## Service Bulletin

SB07-25-04

SEAT BASE/BACK ATTACH FITTING MODIFICATION

Figure 2. Modification of the Seat Base/Back Attach Fittings (Sheet 1)

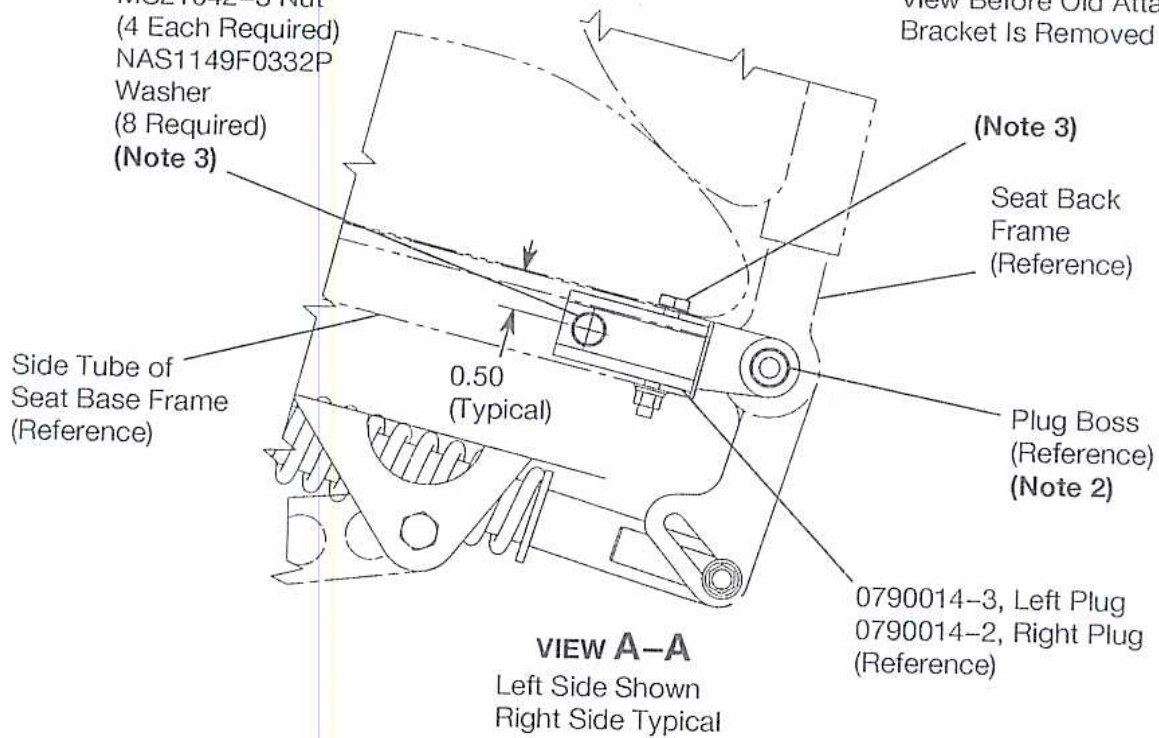
- 14. (Refer to Figure 2, View B-B.) On the two sides of each of the crew seats (and seats 3 and 4 for 206 airplanes), install the seat back frame and the seat belt to the seat base frame as follows: (Refer to the applicable maintenance manual, Chapter 25.)

- A. On the left side of each of the crew seats (and seats 3 and 4 for 206 airplanes), install the seat back frame and the seat belt to the seat base frame with the new AN4-17A Bolt, new MS21042-4 Nut, and the kept attaching hardware.

- B. On the right side of each of the crew seats (and seats 3 and 4 for 206 airplanes), install the seat back frame and the seat belt to the seat base frame with the kept attaching hardware and the new MS21044N4 Nut.

- NOTE 1:** Cut off attach bracket and file remaining end until smooth and flush with rear tube wall.
- NOTE 2:** Make sure that the boss of the left 0790014-3 (0790014-2, right) Plug points away from the crew seat.
- NOTE 3:** Install the NAS1149F0332P Washers with one washer next to the bolt head and one washer next to the nut.
